Access Compliance Report

Public Rights-of-Way

(Curb Ramps)

Intersection ID: N/A	Main Street: MORABLIN_DR	Cross Street: DURANT_BV	Location: SE
ADA ID: 80D9008B80FA	Ramp Type: PerpDiag	Initial Pass/Fail: Fail	Overall Compliance: No
Codes/Mitigation Info/Possible Solution		Field Measurements/Component Compliance

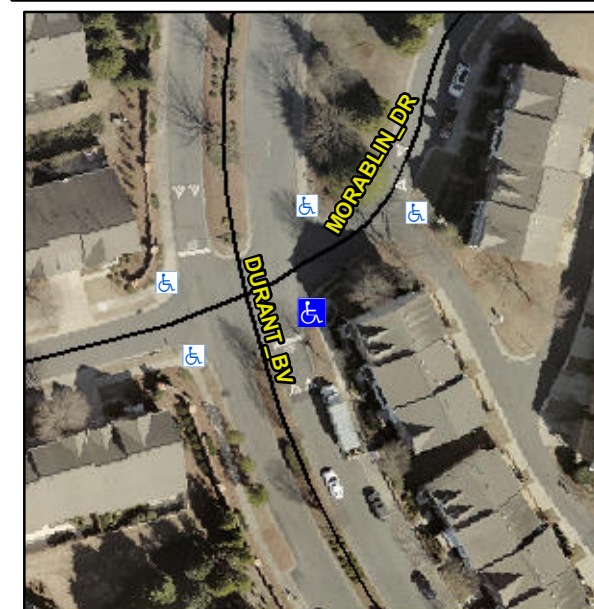
Not Found, R304.5.1, R304.2.2, R304.5.3

Compliance	Description	Data	Compliance	Description	Data
N/A	Ramp Length (in)	120.0	No	Ramp Slope (%)	8.9
No	Ramp Width (in)	32.0	No	Ramp XSlope (%)	2.8
N/A	Flare Type LT	N/A	N/A	Flare Type RT	N/A
N/A	Flare Slope LT (%)	N/A	N/A	Flare Slope RT (%)	N/A
N/A	Flare Traversable LT?	N/A	N/A	Flare Traversable RT?	N/A
N/A	Landing Length (in)	N/A	N/A	DWS Provided?	N/A
N/A	Landing Width (in)	N/A	N/A	DWS Contrast?	N/A
N/A	Landing Slope (%)	N/A	N/A	DWS Length (in)	N/A
N/A	Landing X Slope (%)	N/A	N/A	DWS Full Width?	N/A
N/A	Landing Curb? (Y/N)	N/A	N/A	DWS Offset (in)	N/A
N/A	Shared Landing?	N/A			
N/A	Gutter Ponding?	N/A	N/A	Gutter Slope (%)	N/A
N/A	Gutter Lip Ht (in)	N/A	N/A	Gutter X Slope (%)	N/A
N/A	Painted X Walk1?	No	N/A	Painted X Walk2?	No
	X Walk 1 Direction	To N		X Walk 2 Direction	To W
N/A	X Walk 1 Width (in)	N/A	N/A	X Walk 2 Width (in)	N/A
	X Walk 1 Slope (%)	4.7		X Walk 2 Slope (%)	1.6
	X Walk 1 X Slope (%)	3.3		X Walk 2 X Slope (%)	4.7

Remove & Replace Curb Ramp With Two New Directional Ramps or Equivalent.
